MEMORANDUM

SUBJECT: **Worksession**—Limited Functional Master Plan Amendment for the Intercounty Connector (ICC): Bikeways and Interchanges

PLANNING BOARD DRAFT OF THE INTERCOUNTY CONNECTOR LIMITED FUNCTIONAL MASTER PLAN AMENDMENT

Figure 4 Needwood Road Options

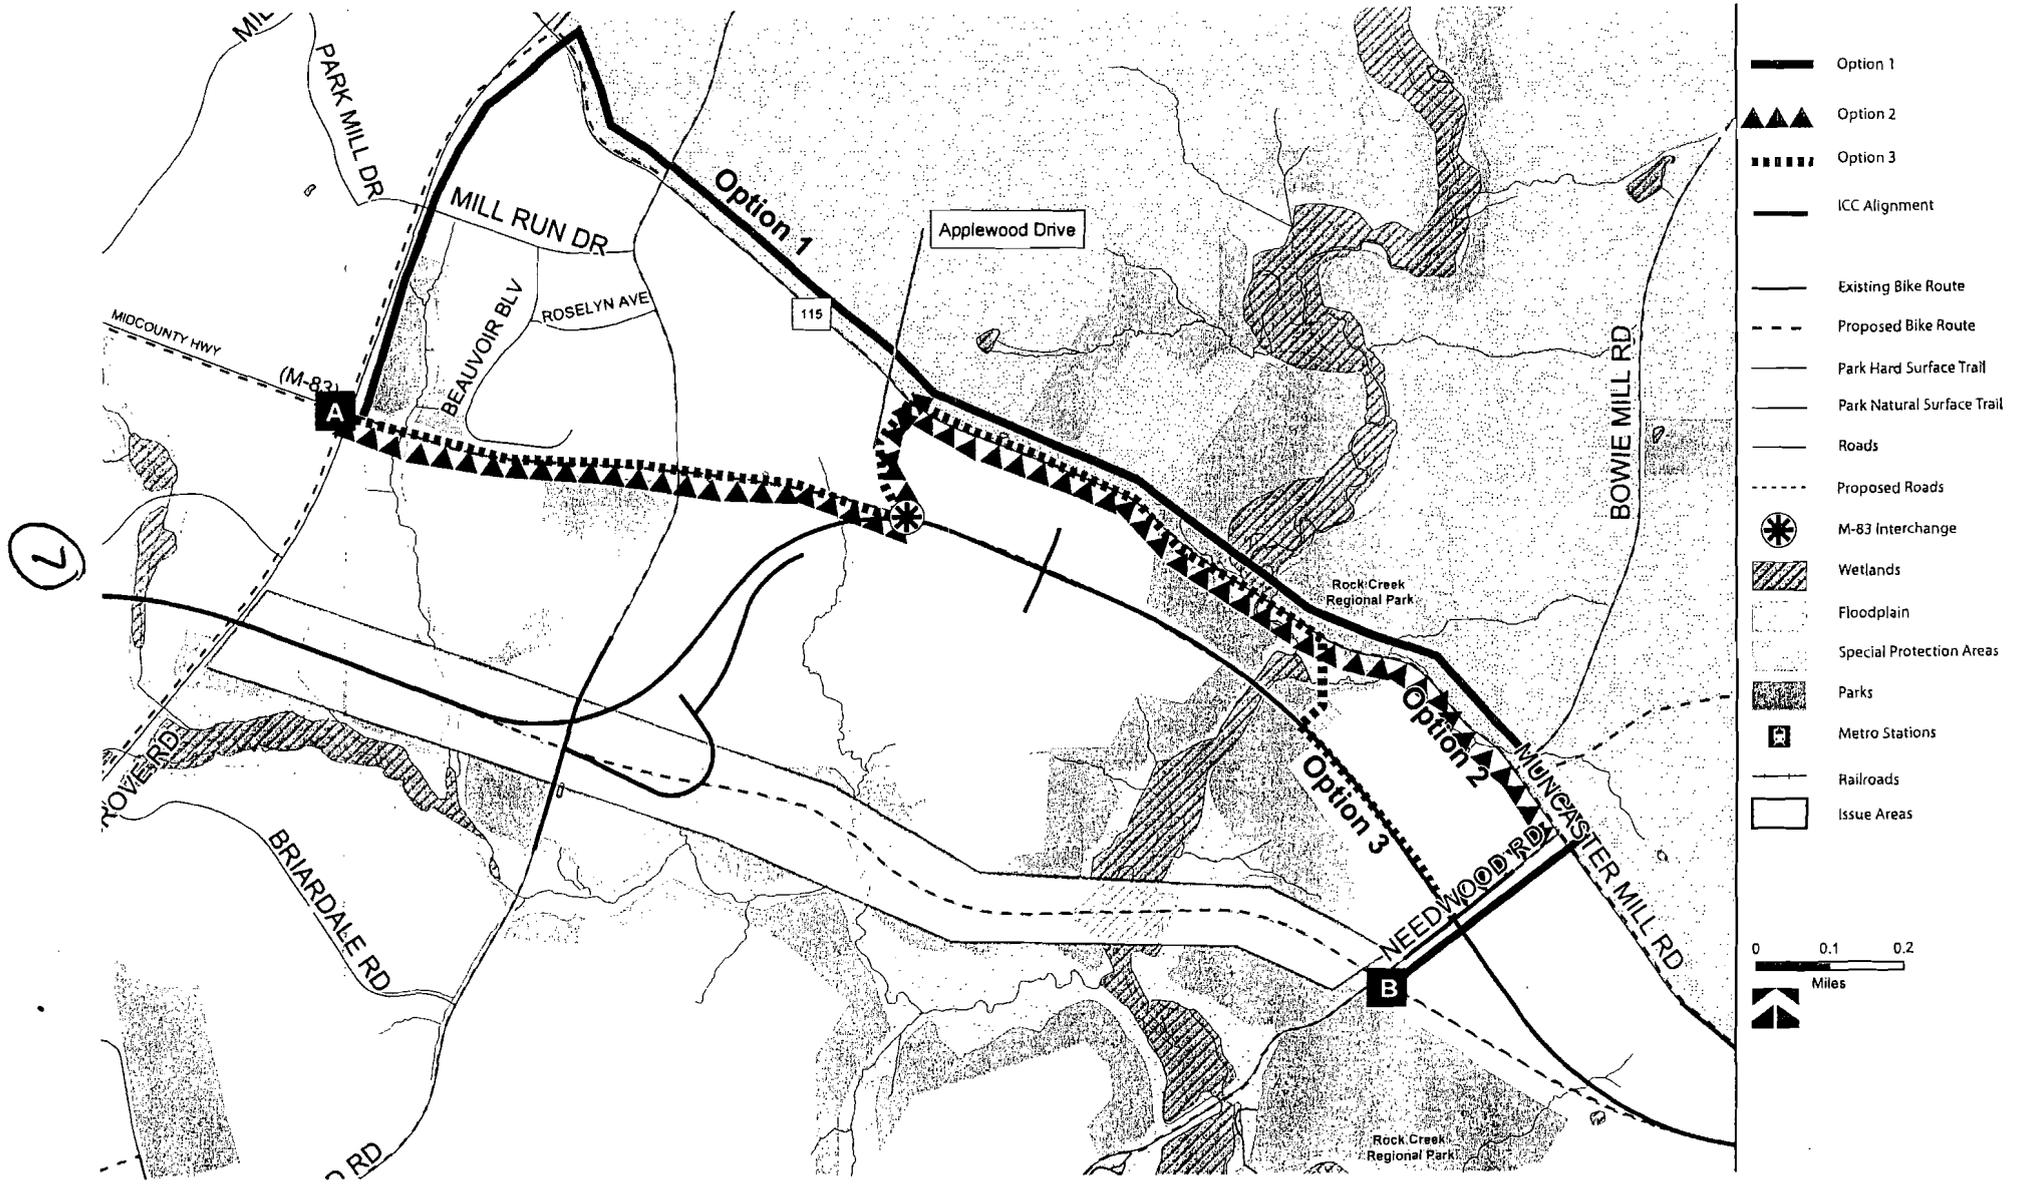
The Board recommends carrying the shared use trail along Needwood Road northeast to Muncaster Mill Road, and from there west along the south side of Muncaster Mill Road to Applewood Lane, where it would connect with the existing shared use path extending west to Shady Grove Road. This is Option 1 on ©7 (page 18 of the Final Draft). The Board also recommends a shared signed roadway (a Class III bike route) be designated on Applewood Lane connecting to a future shared use trail west along the M-83 right-of-way. This is Option 2, and is the preference of DOT as well.

4. For Needwood Road and Vicinity (Study Area A), we support Option 2, primarily because it follows the ICC alignment more closely than Option 1 and appears to have less negative impacts on the natural environment than Option 3.

T&E Committee (and Council staff) recommendation (3-0): Concur with the Final Draft.

Figure 6 Northwest Branch Stream Valley Park Options

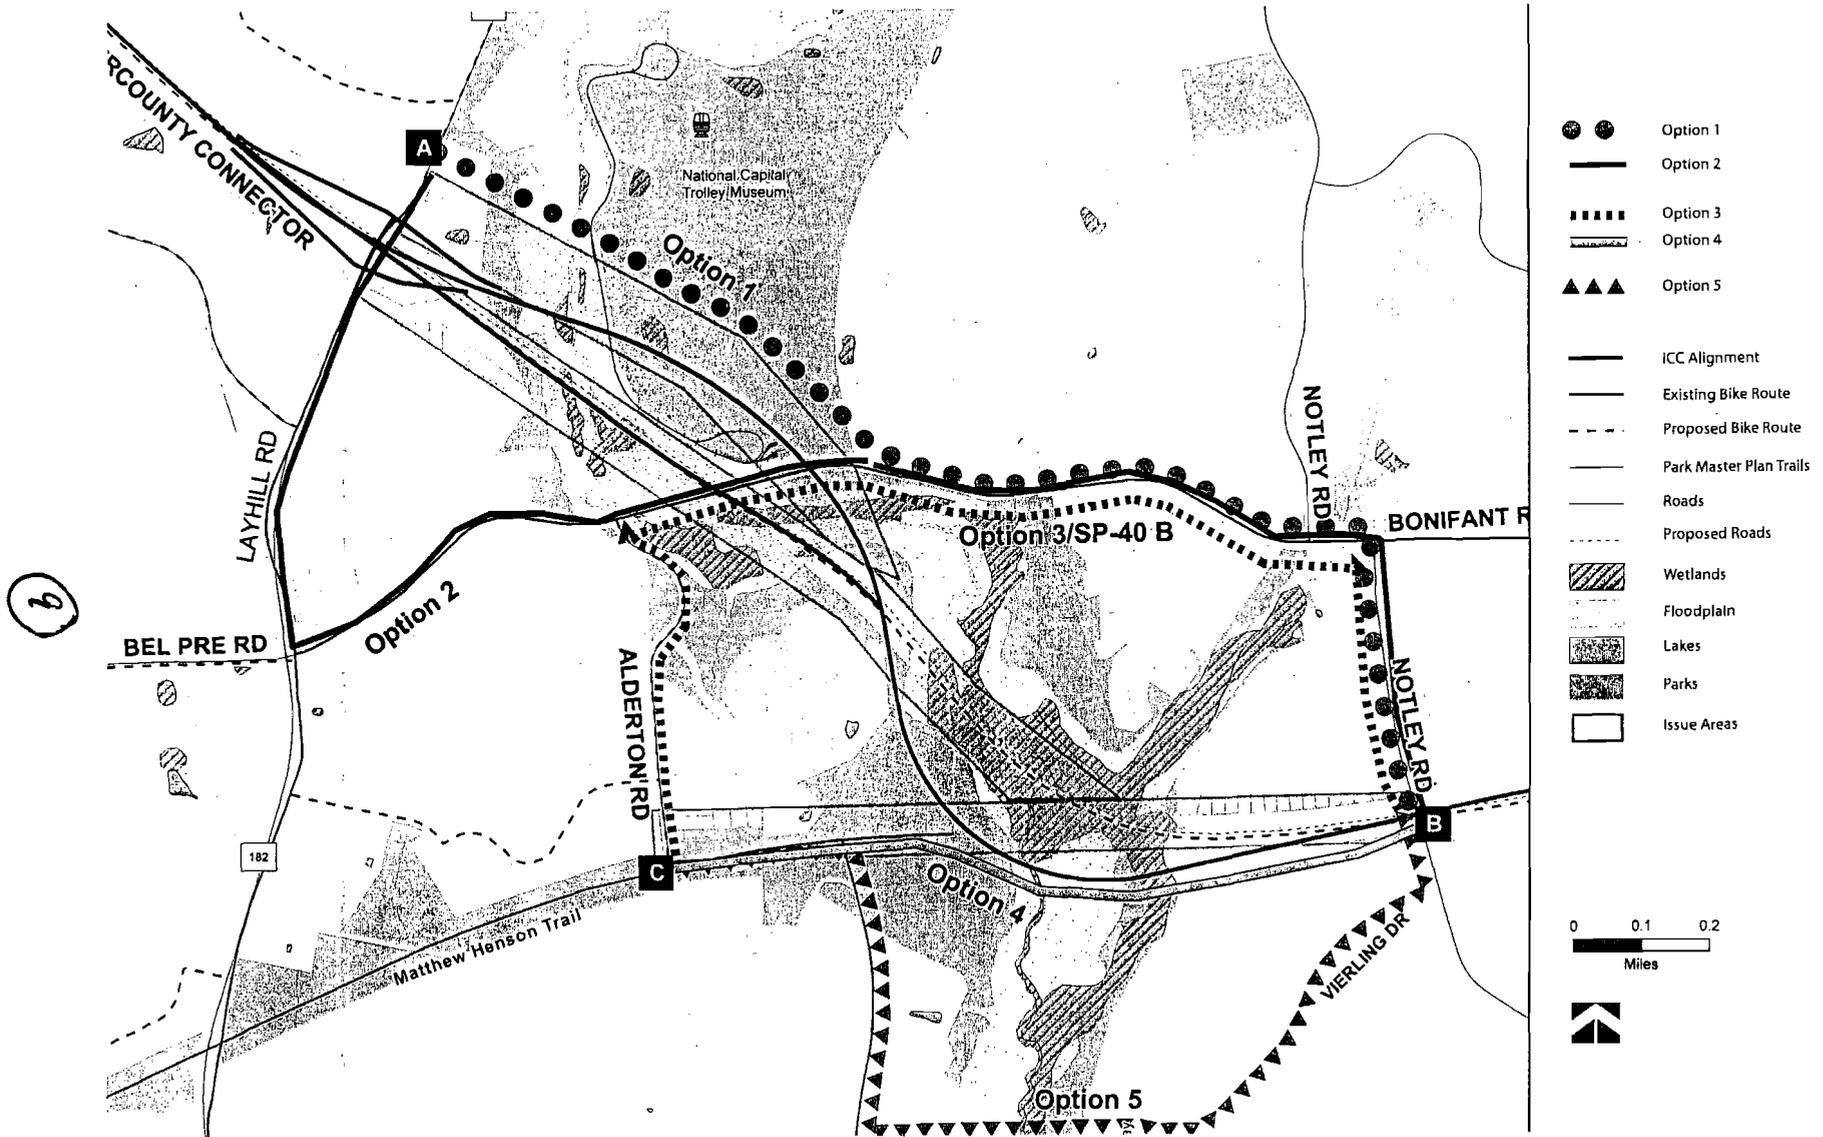
The Board further proposes a connection between the eastern terminus of the Matthew Henson Trail and Notley Road, following either Option 3, Option 4 (a more direct route across the park), or Option 5 detouring south through Indian Spring/Poplar Run and the Drumeldra Hills neighborhood. The route would be based on a detailed environmental study conducted by the Parks Department.

DOT recommends including in the plan the portion of Option 1 between Layhill and Bonifant Roads, the portion of Option 3 west on Bonifant Road and south on Alderton Lane, plus Option 4 connecting across Northwest Branch from the eastern terminus of the Matthew Henson Trail to Notley Road.

5. For Emory Lane/Georgia Avenue and Vicinity (Study Area B), we support retention of the bikeway alignment within the ICC ROW.
6. For Northwest Branch Stream Valley Park and Vicinity (Study Area C), we support the alignment which combines Option 1 from Layhill Road to Bonifant Road via the ICC, Option 3 from the ICC to Alderton Road via Bonifant Road and then from Bonifant Road to the Matthew Henson Trail via Alderton Road, and Option 4 from Alderton Road to Notley Road via the Matthew Henson Trail. This alignment follows less heavily traveled roads than Option 1 alone, or Option 2. It is also more closely follows the ICC alignment, and is less circuitous than Option 5.

T&E Committee (and Council staff) recommendation (3-0): Include Options 1, 3 and 4 in the plan. The Bonifant/Notley route is the most direct between the eastern and western segments of SP-40. Option 3 is the most direct feasible route between the Henson Trail and the western segment of SP-40. Finally, Option 4 is the best connection between the Henson Trail and the eastern segment of SP-40.

Figure 2 Midcounty Highway Interchange

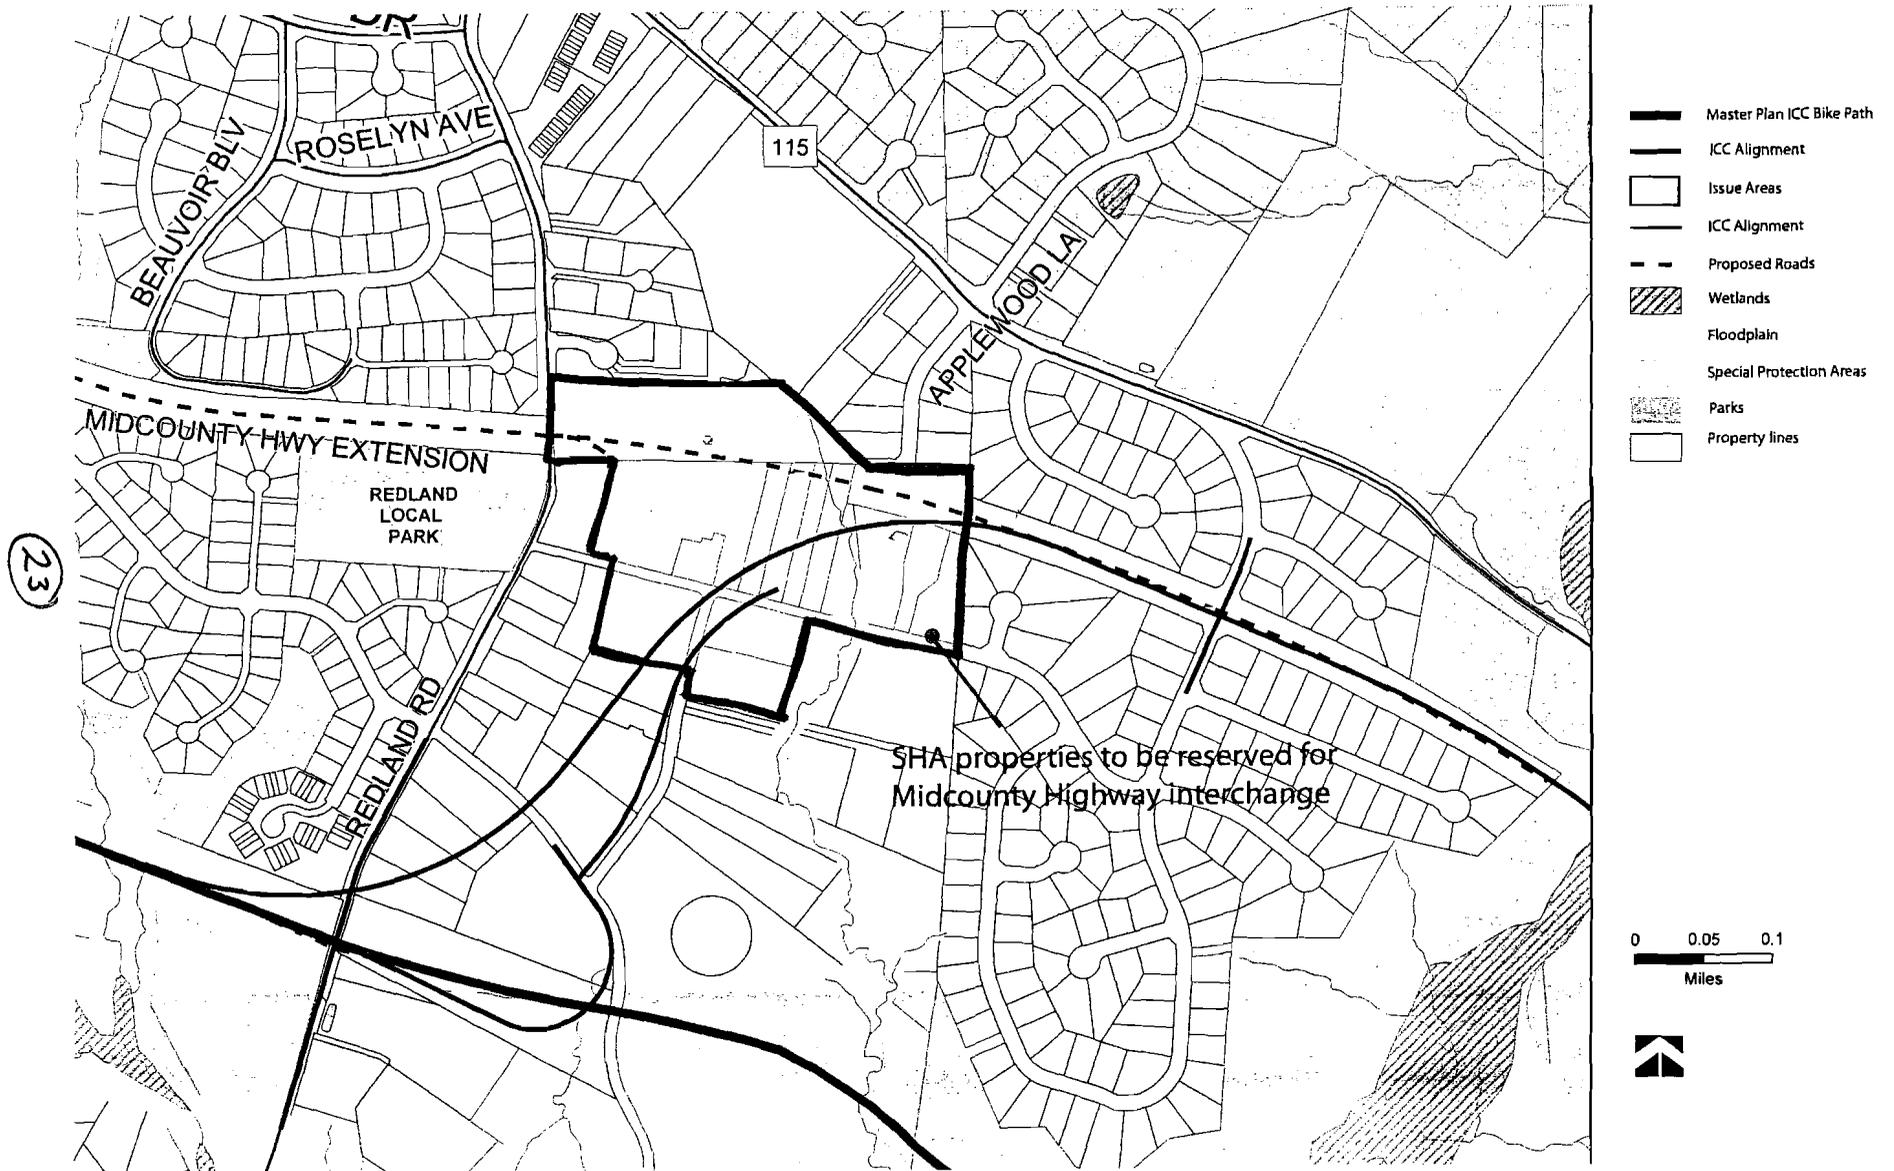
The Council has received a letter from the owner of the parcel at the southwest corner of Garrett and Overhill Roads asking that part of the parcel be excised from the area to be reserved, as well as the adjacent portion of Garrett Road's right-of-way (©24). The diagram on ©25 shows the area that the Planning Board recommends for reservation (speckled area) and the area the property owner wishes not to be included in the reservation (hatched area).

I am writing to submit testimony into the public hearing record for the above-referenced plan. I am the owner of lot 4, block A at the southwest corner of Garrett and Overhill Roads. On Figure 2 (page 12) of the Planning Board Draft my property is shown as one of the "SHA properties to be reserved for Midcounty Highway Interchange."

I am requesting that Figure 2 be revised to show the new boundaries agreed to by the State. Our future plans for redevelopment could be placed in jeopardy if the property is shown as being recommended for reservation. Thank you for your attention to this matter.

The T&E Committee did not have enough information available at its worksession to make a recommendation about this parcel. Subsequently, Council staff received a map showing the boundaries of the area the property owner asks not to be placed in reservation. After reviewing this map, DOT staff reports that while the ramps of the planned interchange would not likely be built within the hatched area, it is possible that the area may still be needed for stormwater management, buffer, or some other ancillary feature. Therefore, DOT concurs with the Final Draft's recommendation. *Council staff recommendation: Concur with the Final Draft.*
